Medworth Energy from Waste Combined Heat and Power Facility

Document Reference Vol.18.2a

Applicant's comments on the Deadline 7 Submissions: Part 1 Statutory Parties

Table 2.1 Comments on CCC/FDC Deadline 7 submission – Comments on the Applicant's D6 Submissions [REP7-043]

Appendix B Location of Acoustic Fence at 10 New bridge Lane

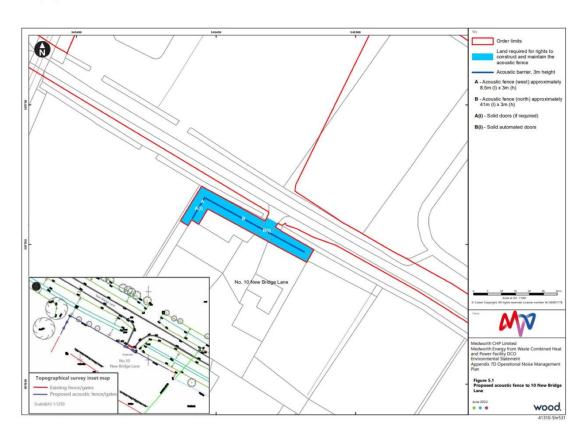
At this point of the application process, the noise barrier design has not been provided. Therefore, there has been no consideration if the introduction of a noise barrier itself will change the current noise exposure 10 New Bridge Lane experiences from the A47. The installation of the noise barrier may result in an increase of road traffic noise from the A47 experienced at 10 New Bridge Lane due to a reflective surface resulting in noise build up and impacting on areas of 10 New Bridge Lane which were previously screened from noise sources such as the rear of the property.

With the assumptions made regarding the characteristics of the noise and the design brief of the acoustic barrier yet to be provided within the planning process, the Councils do not have sufficient information to justify that the noise will be mitigated to a level where it will no longer be significant to 10 New Bridge Lane.

The acoustic fence specification has been designed based on the outputs from the noise assessment supporting the DCO Application (Appendix 7D Outline Operational Noise Management Plan Volume 6.4) [REP3-015]). That assessment includes contributions from HGV's manoeuvring within the EfW CHP Facility Site, but also includes additional contributions from HGV's operating on New Bridge Lane. Furthermore, the Outline Operational Noise Management Plan Rev 4, Appendix 7D, (Volume 6.4) [REP5-014], specifically developed for the DCO application, which addresses the impacts from HGV's on New Bridge Lane, also includes the acoustic fence as a mitigation measure. Conditions to adhere to this management plan, whilst supporting ongoing access to the acoustic fence and the requirement to construct and maintain it throughout the lifetime of the Proposed Development, would be secured by DCO Requirements.

The critical aspects of the design of the acoustic fence are the height and length of the fence. These aspects are defined in the figure within Section 5 of **the Outline Operational Noise Management Plan [REP5-014]**. Other details of the fence will be confirmed at the detailed design stage. The acoustic barrier is subject to design and procurement, but early discussion with one supplier has identified an acoustic barrier meeting a surface density of 26kg/m^2 , and in all cases, a performance greater than 20kg/m^2 would be sought. The moving gate will be clad in the same material and the threshold gap will be designed to minimise flanking.

Topic/Para	CCC/FDC Representation	Applicant Comment
		It is most unlikely that the fence would cause any appreciable increase in road noise from the road traffic on the A47 due to reflected sound. There are a number of structures present at 10 New Bridge Lane, including the dwelling itself, which provides significant screening from noise from the south that would reduce reflected sound from the fence. Additionally, during the baseline surveys, industrial and commercial sound was found to be dominant at 10 New Bridge Lane with road noise also a significant contributor. On this basis, it is most unlikely that any reflected road noise would cause any material change to the ambient noise levels at 10 New Bridge Lane. Based on the above, the Applicant's position remains that the
		acoustic fence provides sufficient mitigation and that there will be no significant effects to 10 New Bridge Lane.
		To assist CCC/FDC's understanding on how the regulatory frameworks of the DCO and Environmental Permit would operate, further information for the design and maintenance of the acoustic barrier was issued on 19 July 2023, see Appendix A (Technical Note: Regulation of Noise Controls (acoustic fence), (July 2023)).
